Re: Comments on Draft EIS for Whistling Ridge Energy Project  
DOE EIS - 0419: Failure to Consider Alternatives

### Comment on Whistling Ridge Energy Project

Specific DEIS Comments from Save Our Scenic Area (SOSA)

Exhibit 2A, page 2

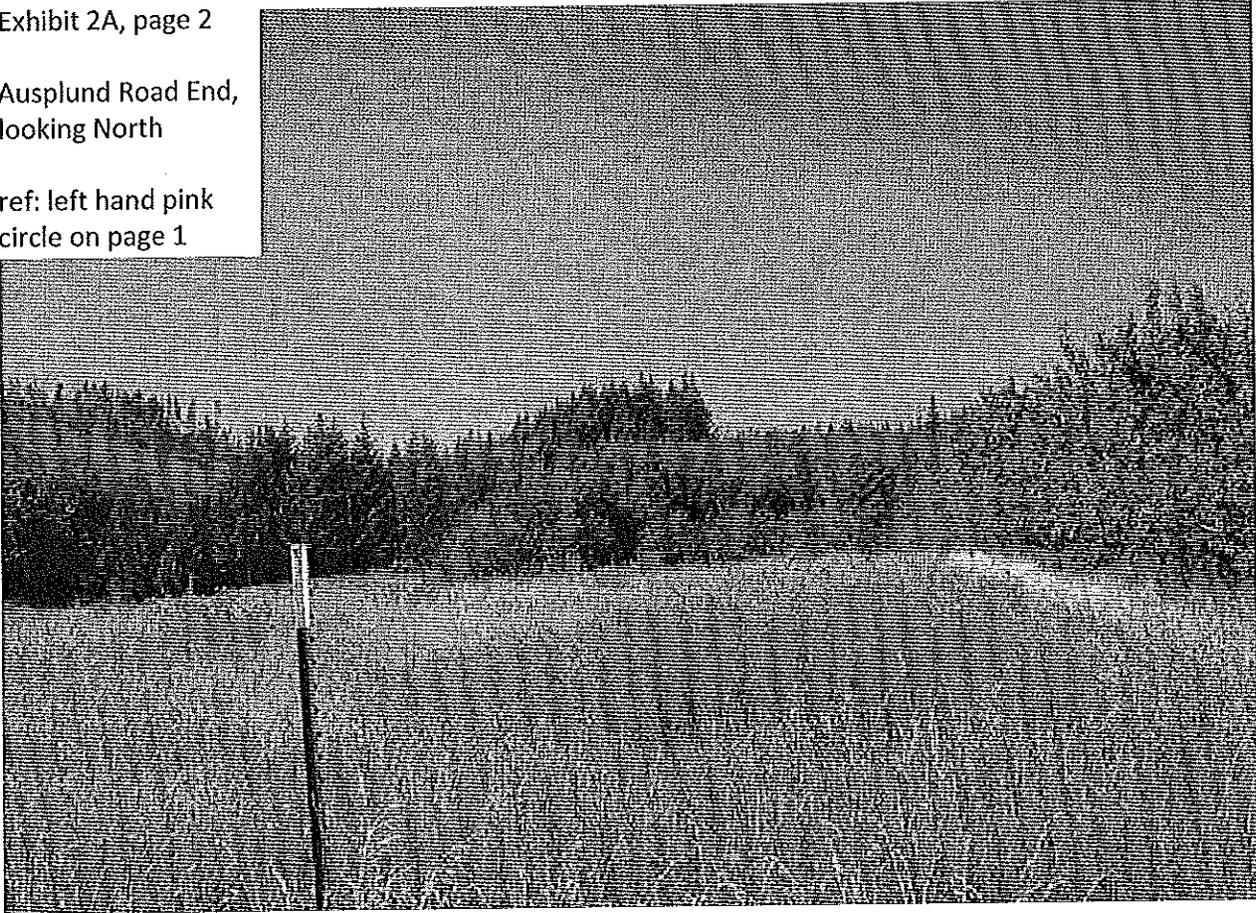
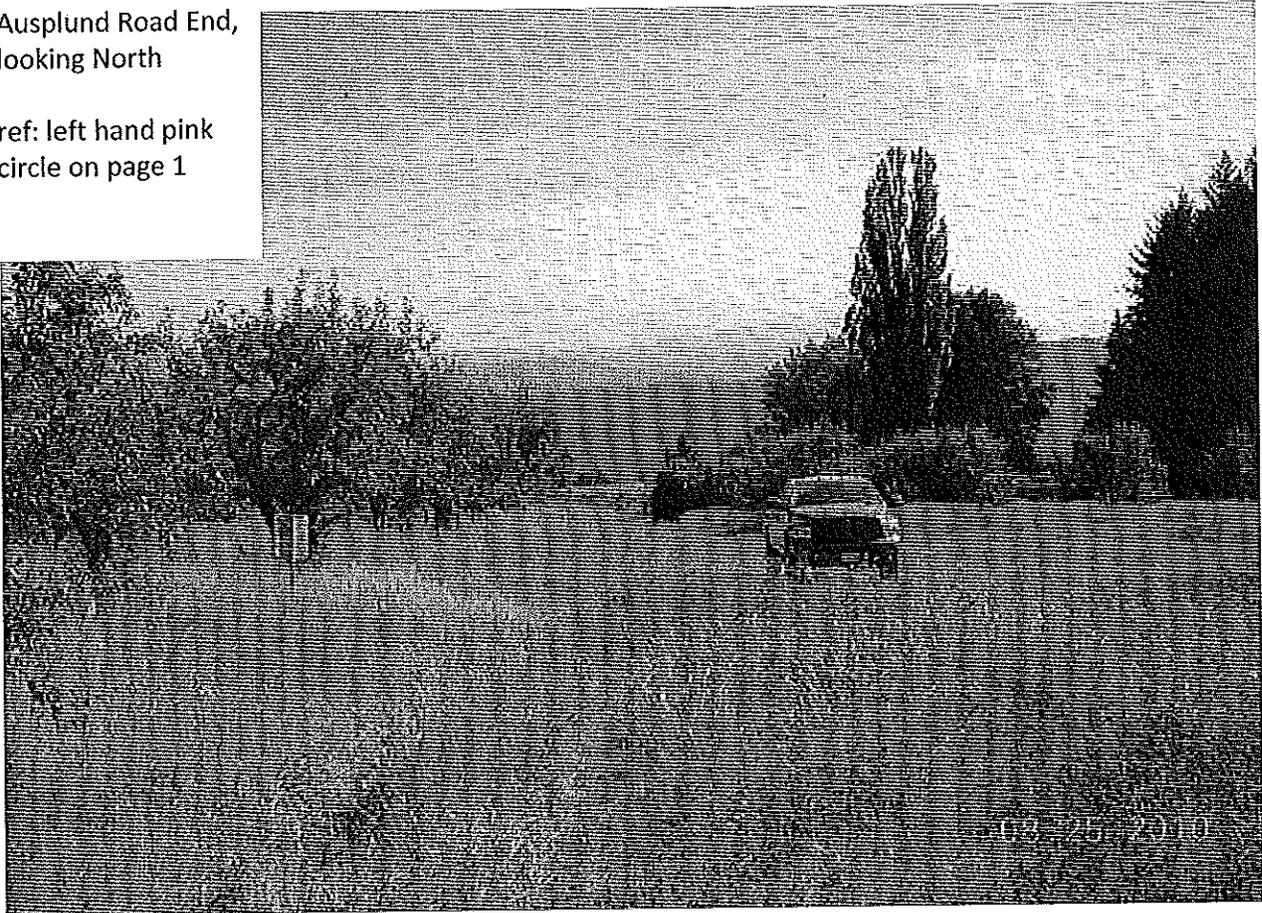
ref: left hand pink  
circle on page 1

Exhibit 2D, page 2

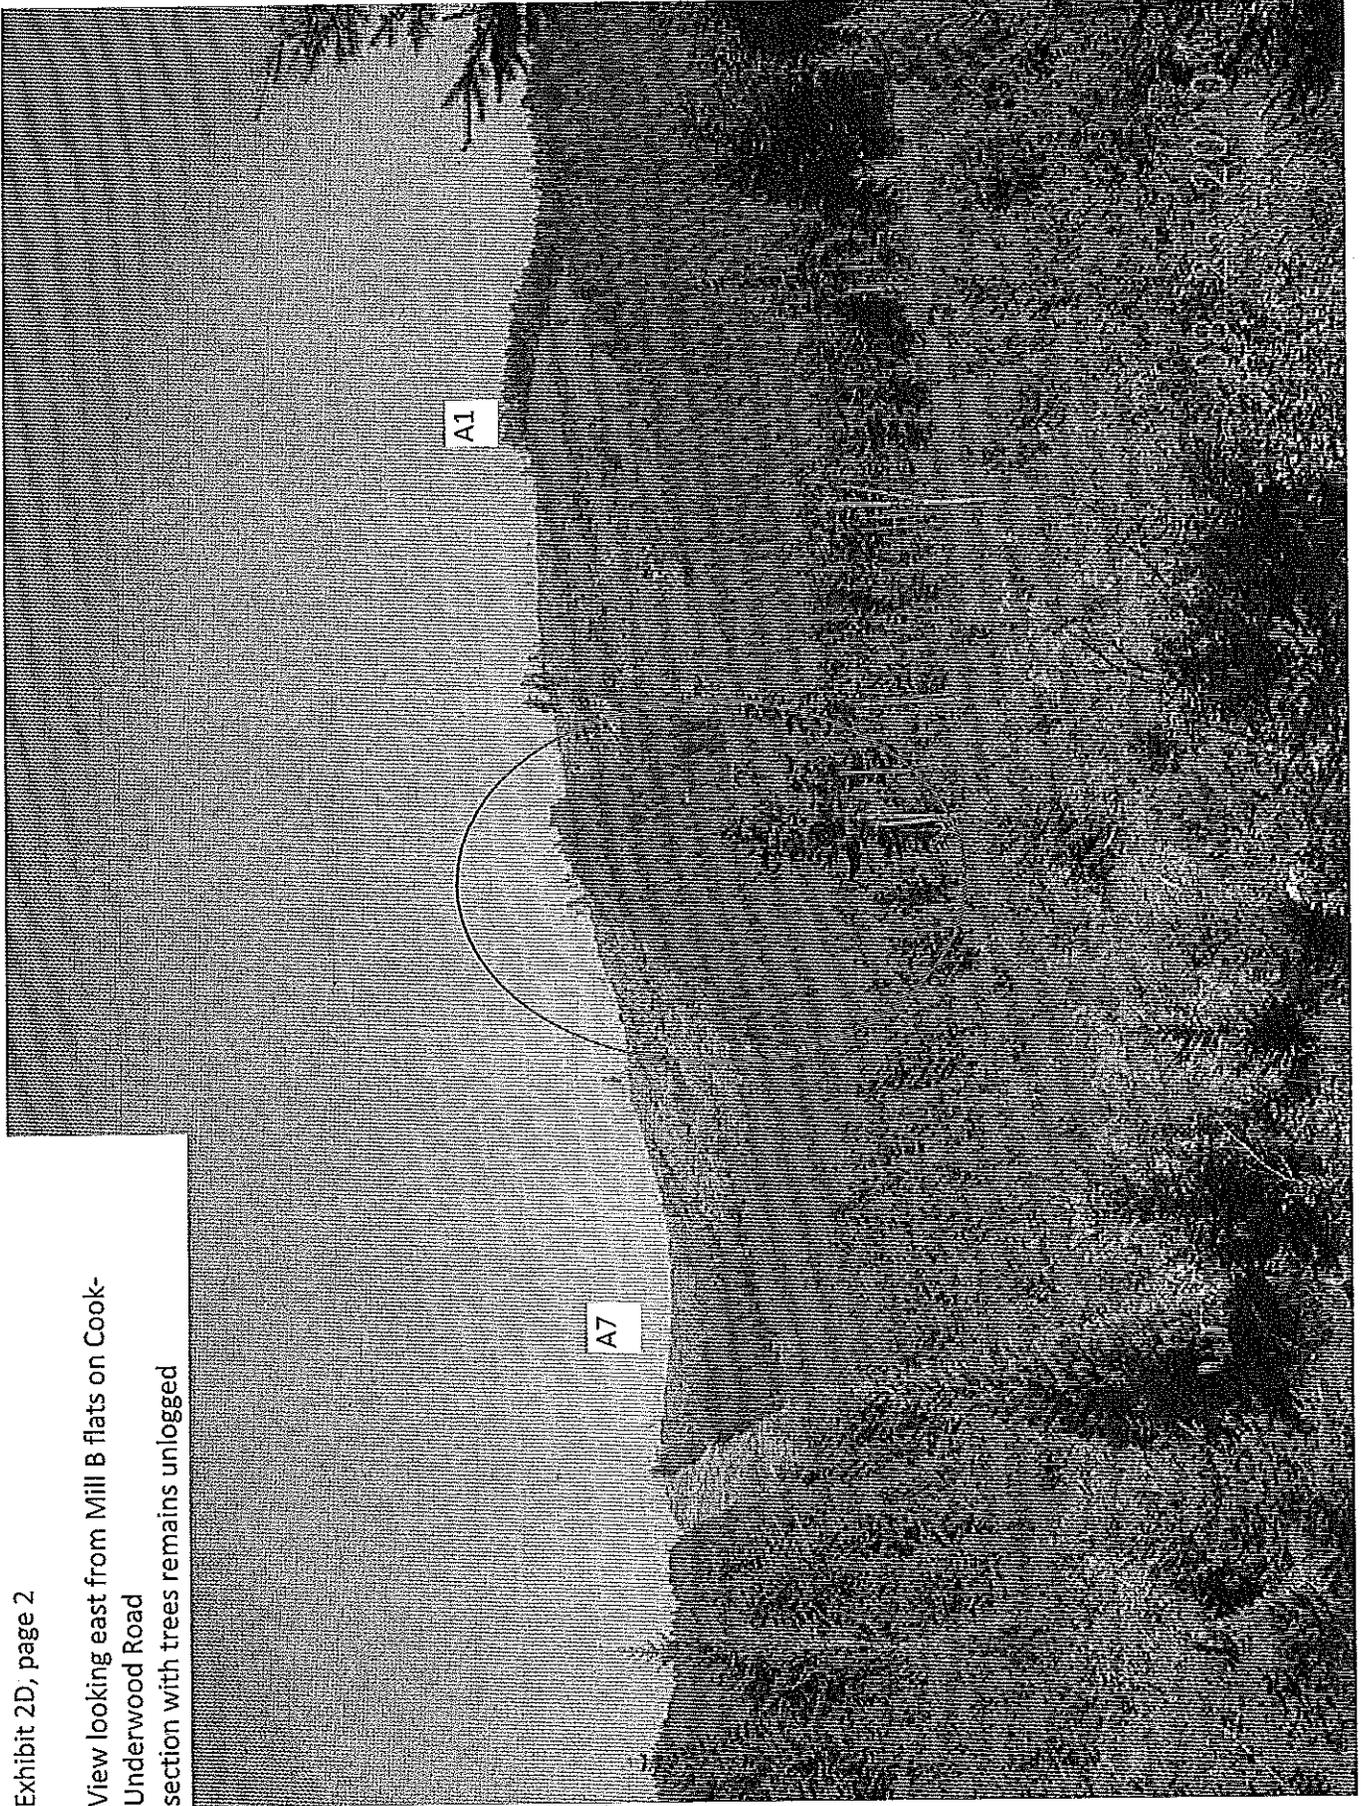
The forested area inside the "red oval" above was not logged. Note that both sides have been clear cut in 2003-4 on this 70%+ slope. Ref FPA's 2702754 and 2702799

The SEPA responsible official should investigate the nature of this area being restricted from logging, and what other information the DNR might have on this issue. They may contact the FP Forester named in the above FPA's, Tony Gilmer, who is still a State employee. contact Department of Natural Resources, Husum Office 509-493-3218 x222 for his contact information
